# Access Compliance Report

## Public Rights-of-Way

| Intersection ID: 52608                  | Main Street: W_MALLARD_CREEK_CHURCH_RD | Cross Street: ALEXANDER_VILLAGE_MAIN_DR | Location: SW           |
| ADA ID: 97F147AF41B0                    | Ramp Type: BlendTrans2                 | Initial Pass/Fail: Pass                 | Overall Compliance: No |

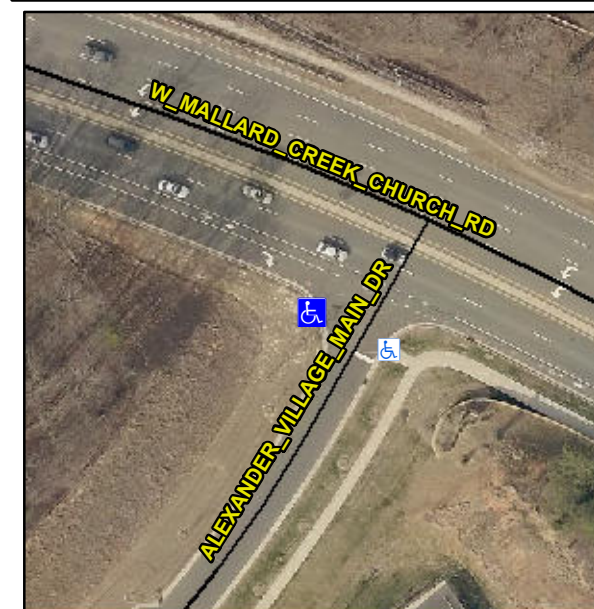
**NO SW**

**R305.2, R304.5.3**

| Compliance | Description           | Data                 | Compliance | Description                 | Data                 |
|------------|-----------------------|----------------------|------------|-----------------------------|----------------------|
| N/A        | Landing Curb? (Y/N)   | No                   | No         | DWS Offset (in)             | N/A                  |
| Yes        | Gutter Lip Ht (in)    | 0.0                  | No         | Gutter X Slope (%)          | 3.9                  |

**Remove & Replace Detectable Warning System. Remove & Replace Gutter.**
